TB-MP016

TECHNICAL BULLETIN

For the At	Graham Mears, Larry Power, Peter Amura, Contract ention of : Managers, Service Branch Managers, Testers, Margaret Pitman	
From:	Pete Canning – Product Support Manager (Passenger Lifts)	
Date :	29February 2016	
Product :	MP	
Subject :	VVVF Transformer Failure Version 2	
Pages :	3

How to identify a faulty drive (Caused by Transformer failure.)

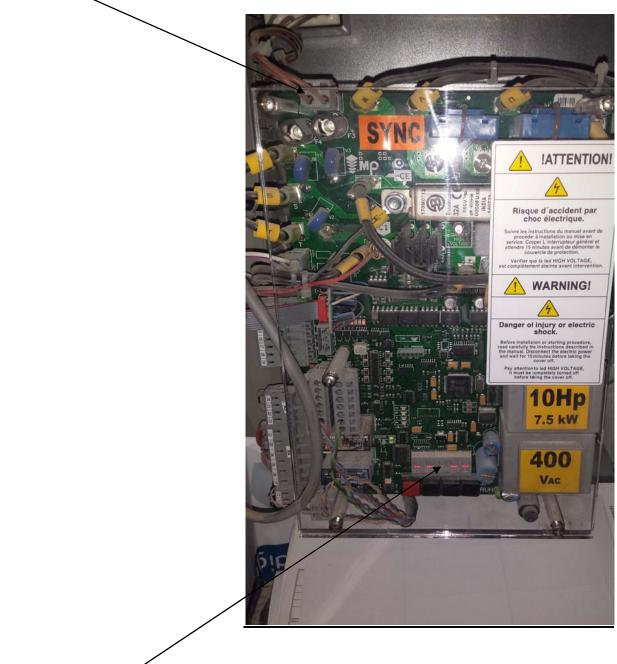
XC12 Plug will have 415 volts on it but the display will be blank.

XC12 Plug

No Display shown here (The picture shows the normal display.)

Procedure for Installing the new Drive unit.

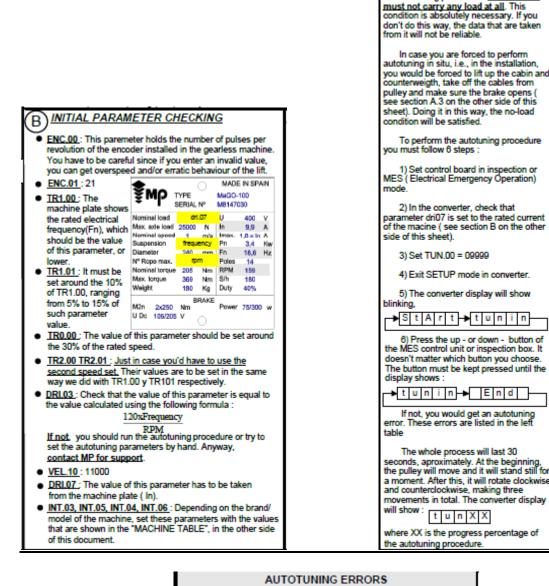
AUTOTUNING There is just one condition to perform the autotuning procedure : the machine
